## ORIGINATION FORM

### Proposed Revisions to a Standard Plans Index (Please provide all information — Incomplete forms will be returned)

Index Number: 522-002

Index Title: Detectable Warnings and Sidewalk Curbramps

=====**CURB RAMP NOMENCLATURE**=====

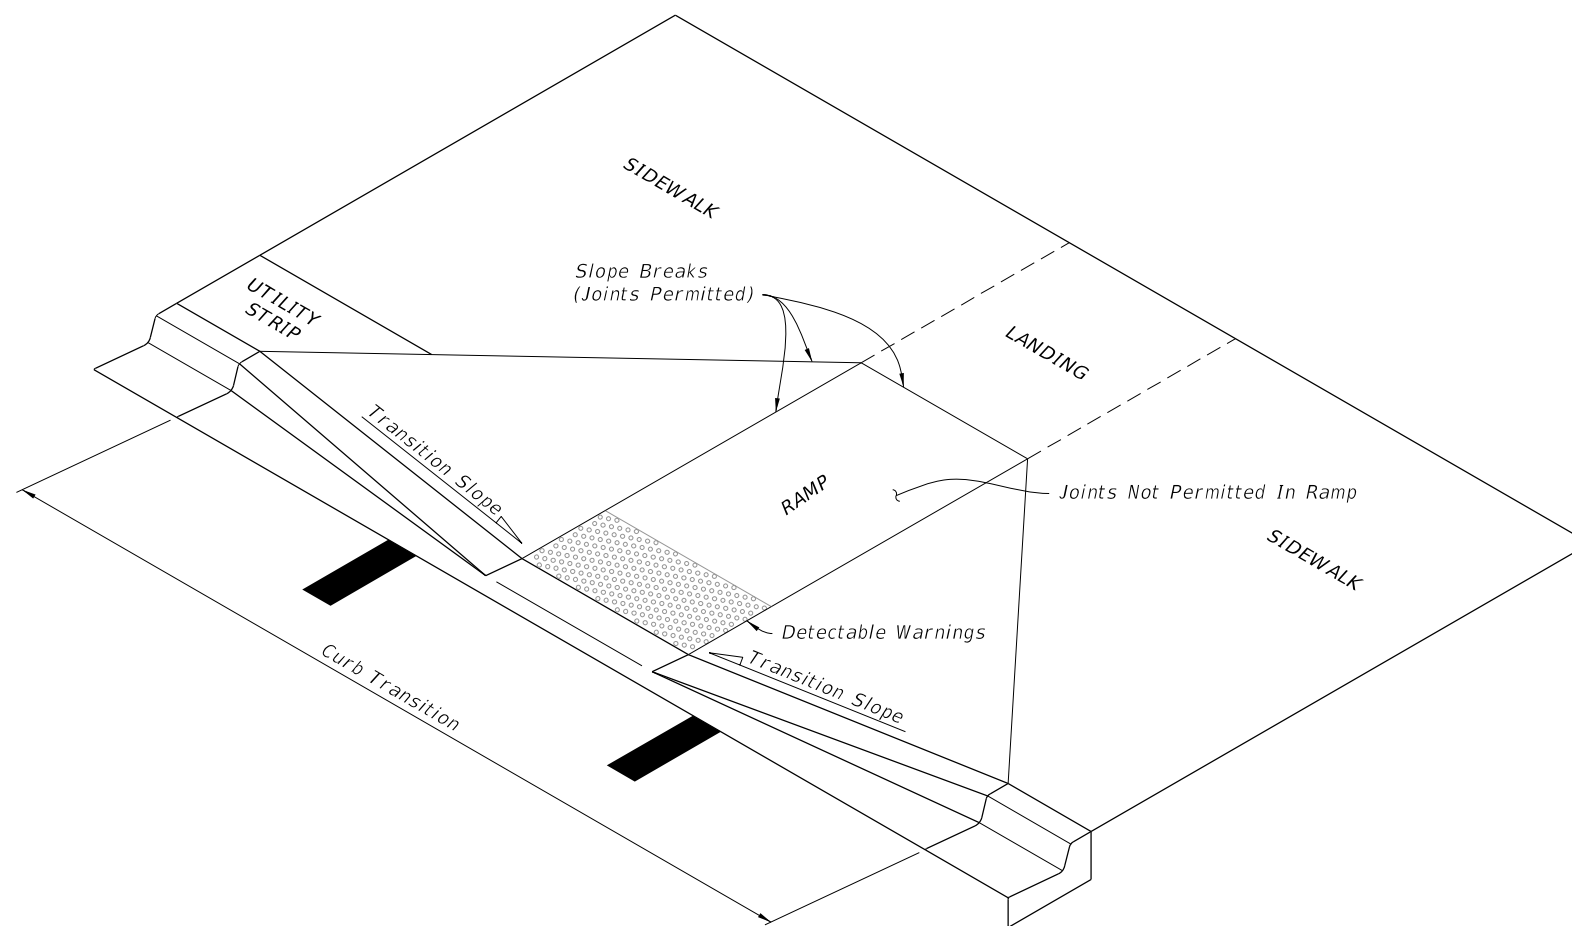
Sheet 1: Deleted General Notes #5: Detectable Warnings - Acceptance Criteria.

As long as the requirements of ADA STF 705 are a condition of being on the APL, there's no need for Note #5 in the SP. Note #5E is covered by the ADA standards and by the phrase, "securely installed even with the substrate" in our updated spec – meaning, there's no abrupt change in level at the edge of the dome mat.

SIDEWALK CURB RAMPS CR-A AND CR-B

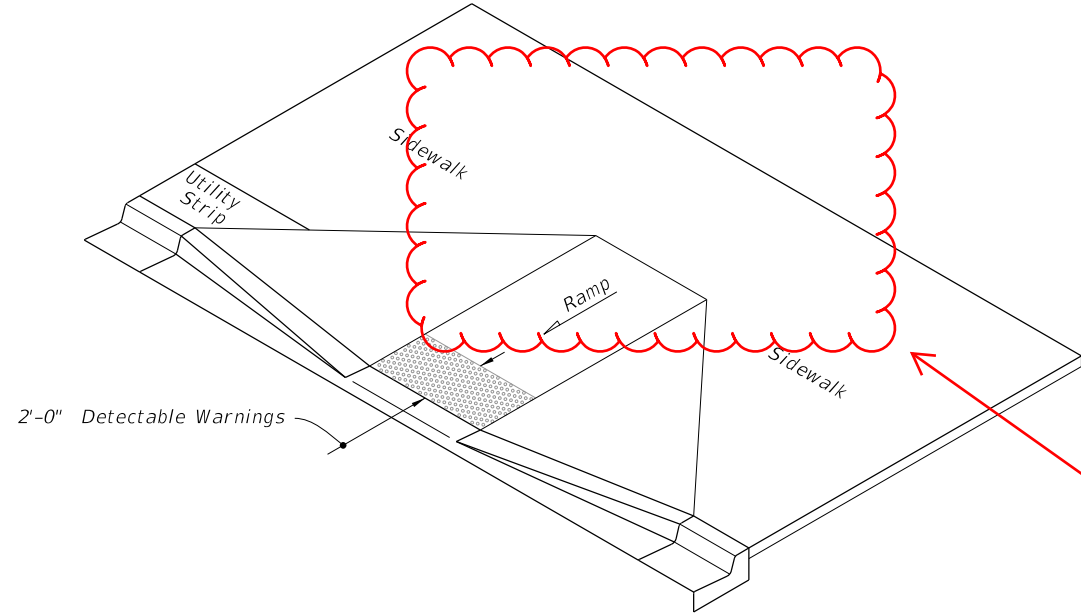
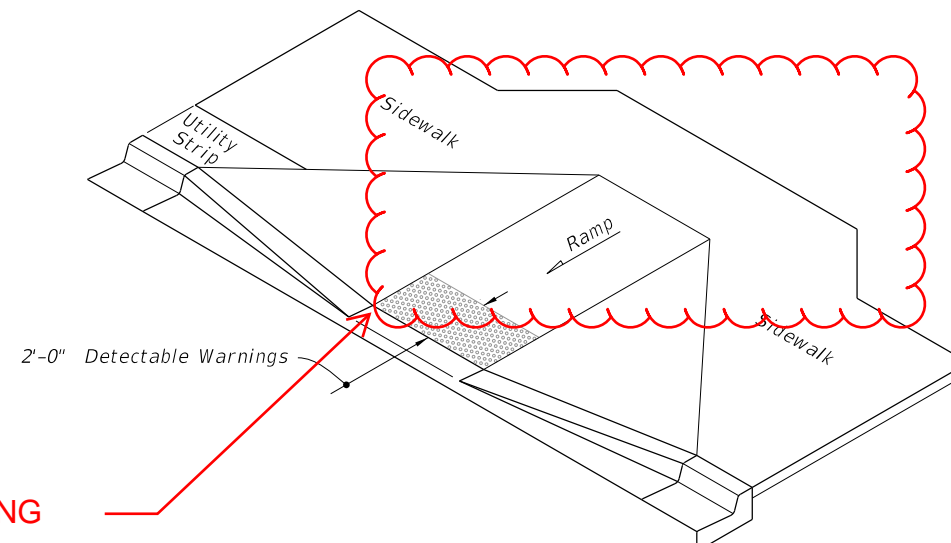
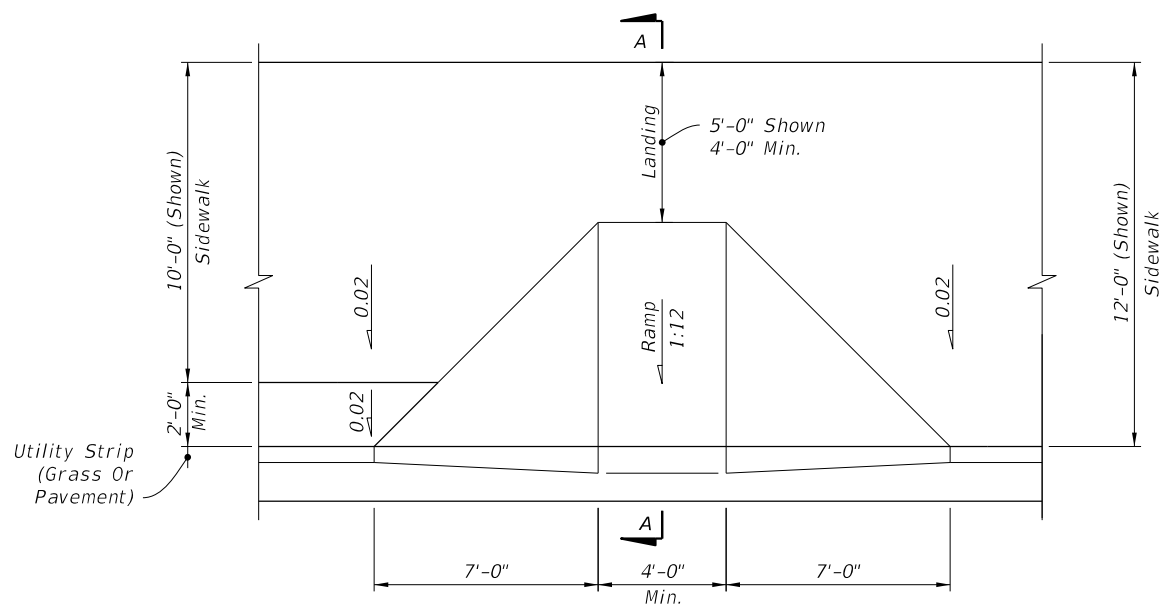
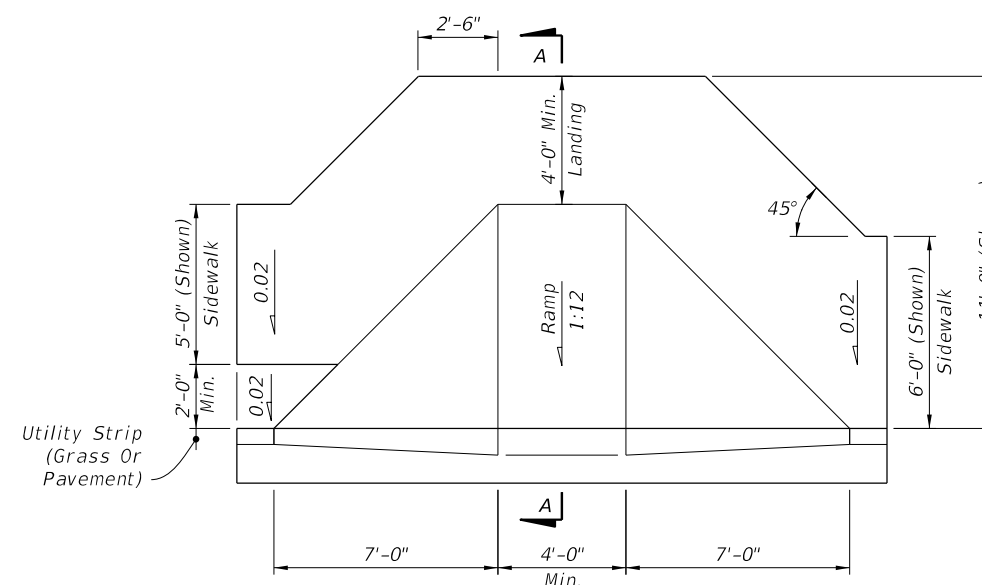
Sheet 2: Added Landing to isometric views

ADDED LANDING

**RAILROAD CROSSING AND CURB RAMPS AT CURBED RETURNS**

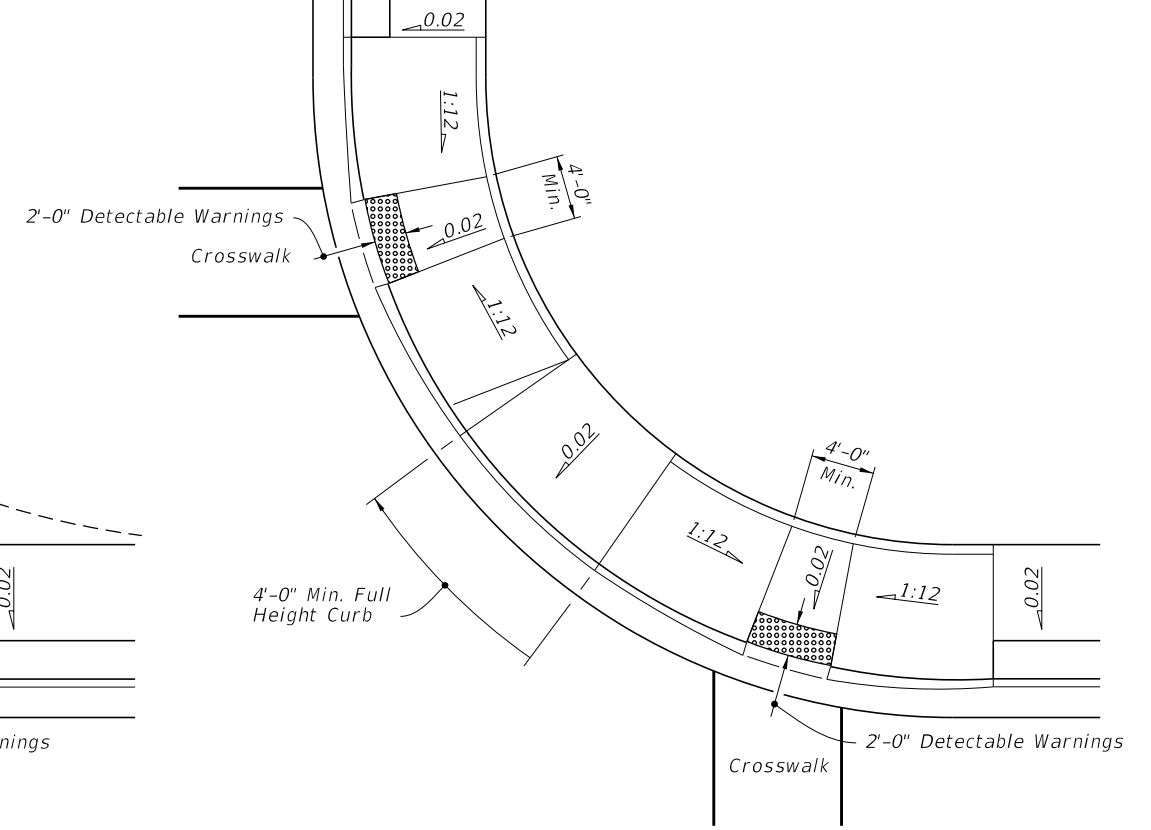
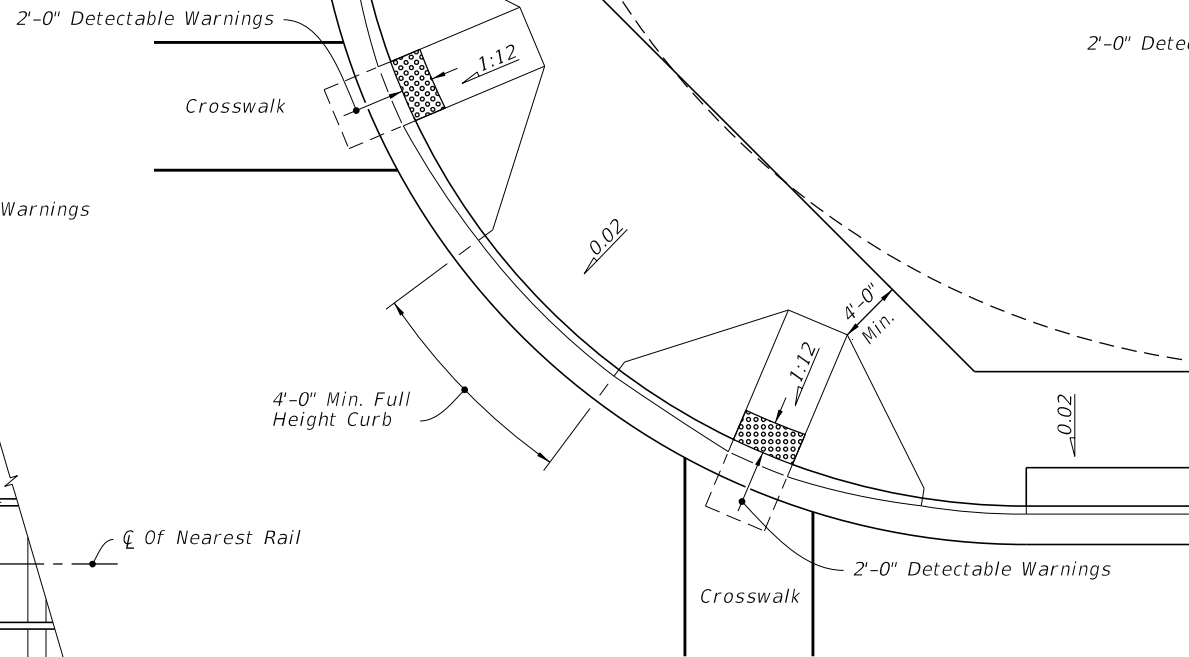
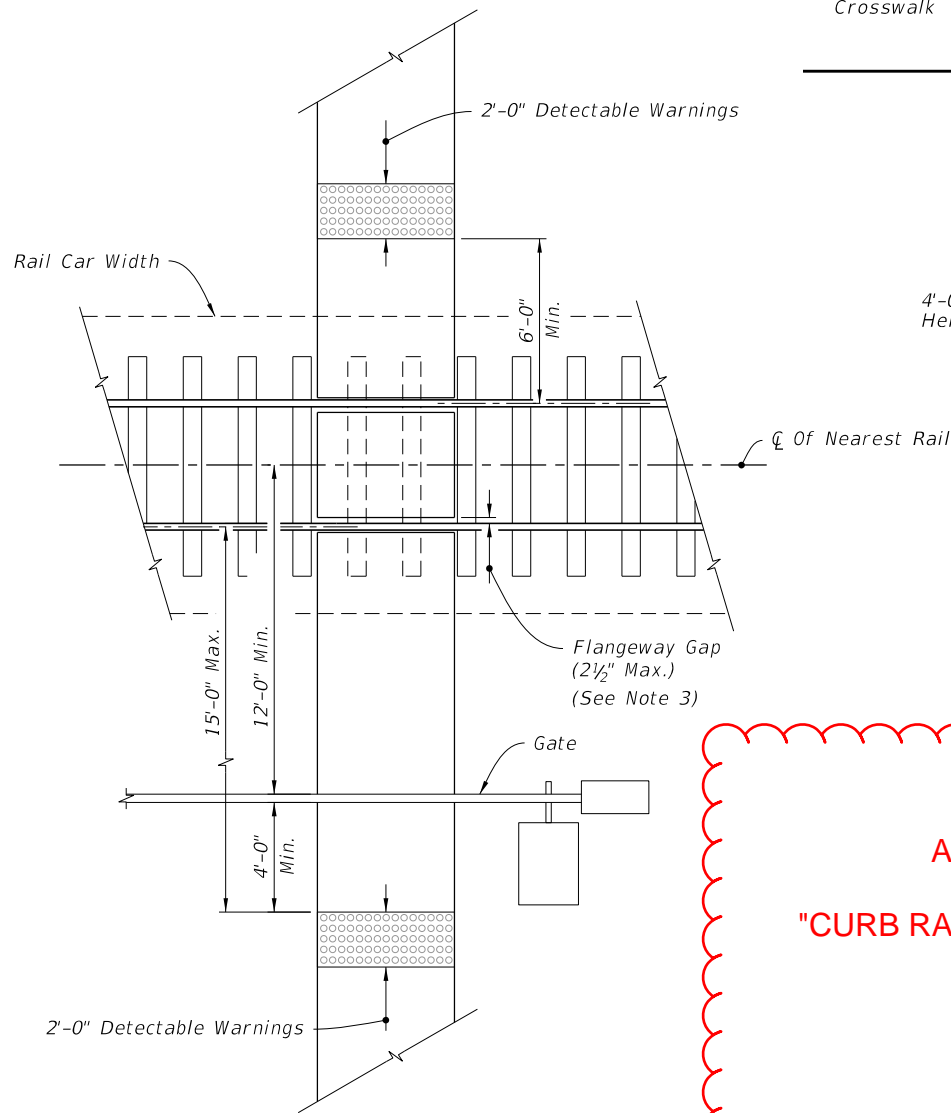
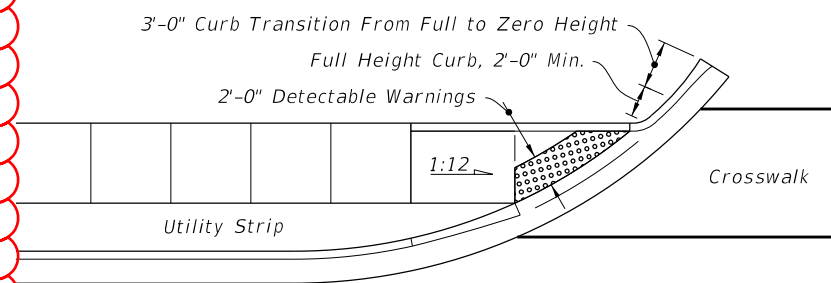
Sheet 7: Added New Detail "Curb Ramp Outside Radial Return"

**ADDED NEW DETAIL**  
**"CURB RAMP OUTSIDE RADIAL RETURN"**

**RAILROAD CROSSING AND CURB RAMPS AT CURBED RETURNS**

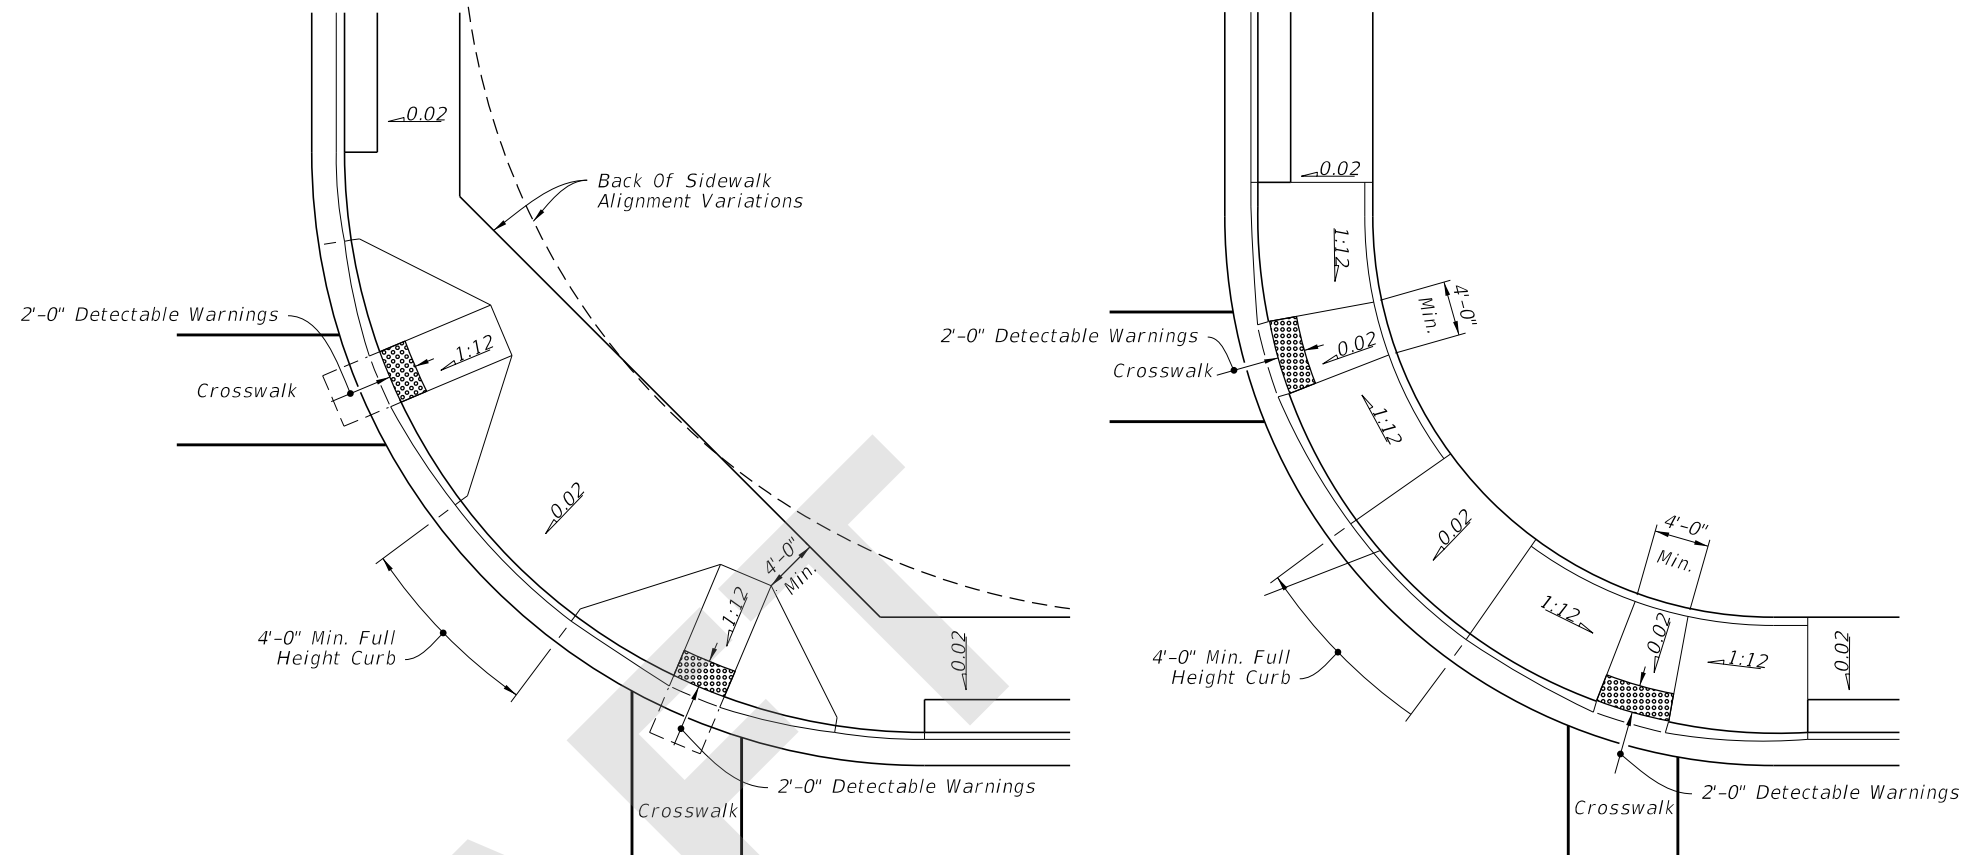
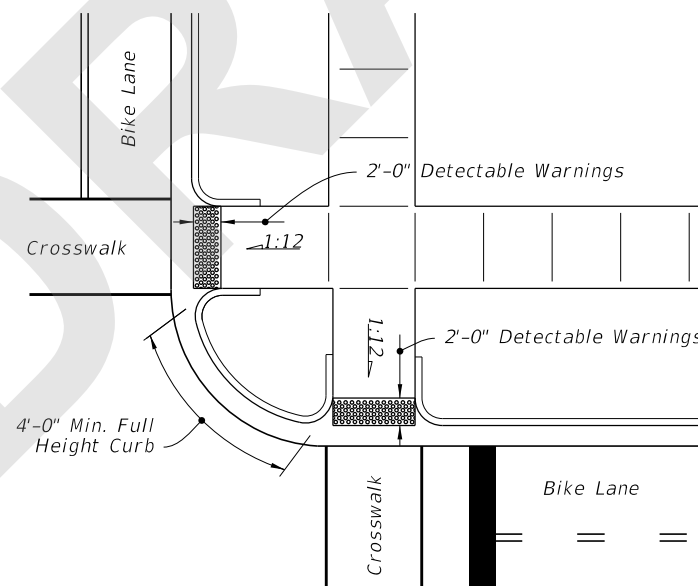
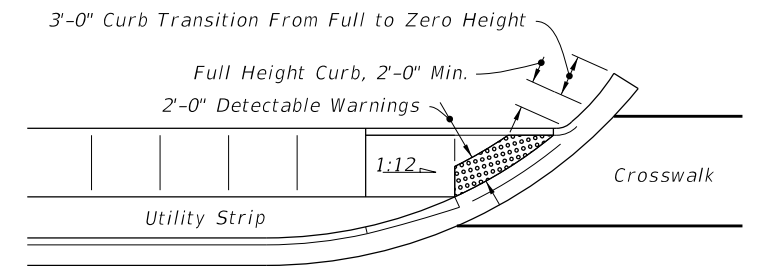
**CURB RAMPS OUTSIDE RADIAL RETURN**
